Change in APDA
 Date Filed 4/29/2024
 Initial notice date 5/7/2024
 DPD issued date
 PD issued date 9/16/2025
 PD notice date 9/16/2025
 Date of FO 12/30/2025 Vol 138 Page 238-243

App# G-15887Per # G-16312Cert # 95849PR Date 12/5/2002

WATER RIGHT TRANSFER COVER SHEET

Theis Drawdown Analysis, Proposed APOA "AN Well" to WASH 79189**Theis Time-Drawdown Worksheet v.5.00**

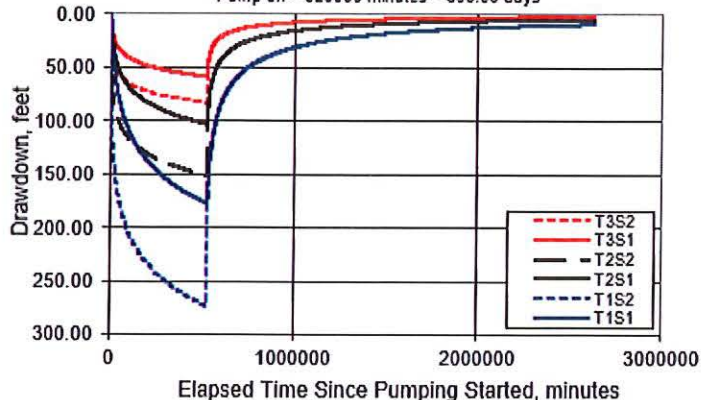
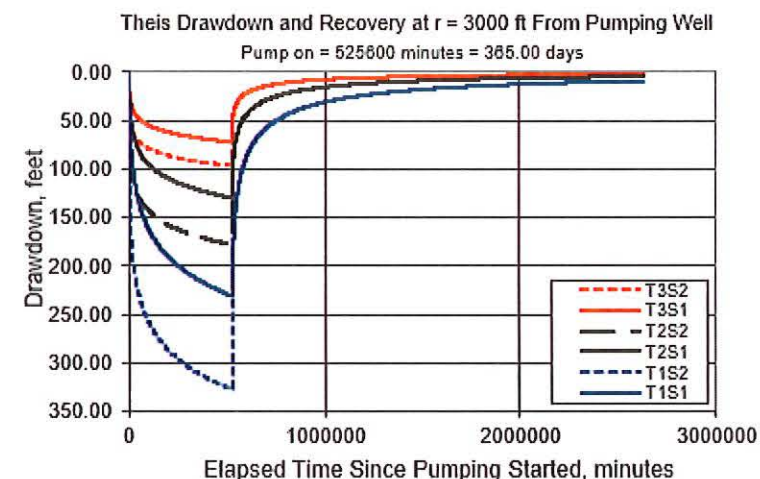
☒ Yes ☐ No Comments: Relative to the location of authorized POA WASH 62373, several of the proposed APOA locations are nearer to existing groundwater rights. Thus, this proposed change will likely result in an increase in interference with those rights.

Limited water level data from another nearby similar well (WASH 56924) indicates that the static water level in WASH 79189 likely ranges from about elevation 180 to 200 ft msl, which would provide roughly 200 feet or more of available drawdown in both it and existing wells of similar completion. This approximate range of available drawdown should be sufficient to support ongoing usage of these wells with the change proposed by this application (i.e., the change will not prevent those wells from receiving the groundwater to which they are legally entitled).

Theis Drawdown Analysis, Proposed APOA "AN Well" to WASH 79189**Theis Time-Drawdown Worksheet v.5.00**

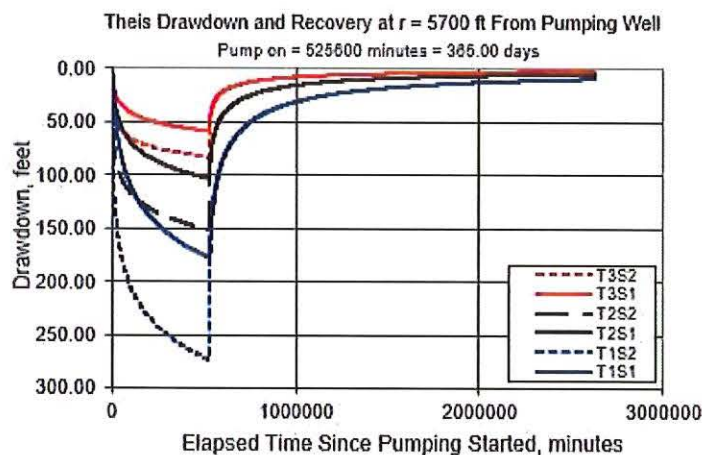
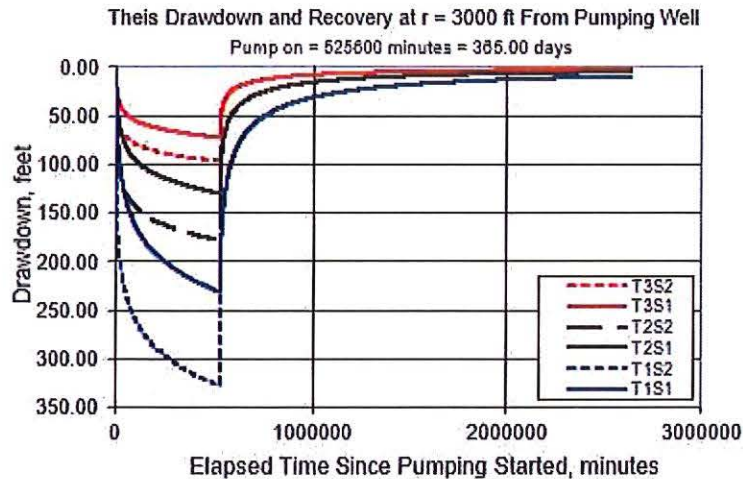
☒ Yes ☐ No Comments: Relative to the location of authorized POA WASH 62373, several of the proposed APOA locations are nearer to existing groundwater rights. Thus, this proposed change will likely result in an increase in interference with those rights.

Relative to the location of authorized POA WASH 62373, the proposed location for the "AN Well" is about 2700 feet nearer to WASH 79189. The results of the Theis interference analysis indicates that additional interference in WASH 79189 could potentially range from about 10 to 50 feet due to pumping the *stacked* maximum rate (1.67 cfs) 24/7/365 from the "AN Well" (see attached Theis analysis results). Limited water level data from other nearby wells (WASH 56924) indicates that the static water level in WASH 79189 likely ranges from about elevation 180 to 200 ft msl, which would provide roughly 200 feet or more of available drawdown in both it and existing wells of similar completion (i.e., those wells that fully penetrate the upper WBZ present from ~ elevation -125 to -250 ft msl). This approximate range of available drawdown should be sufficient to support ongoing usage of these wells with the change proposed by this application (i.e., the change will not prevent those wells from receiving the groundwater to which they are legally entitled).
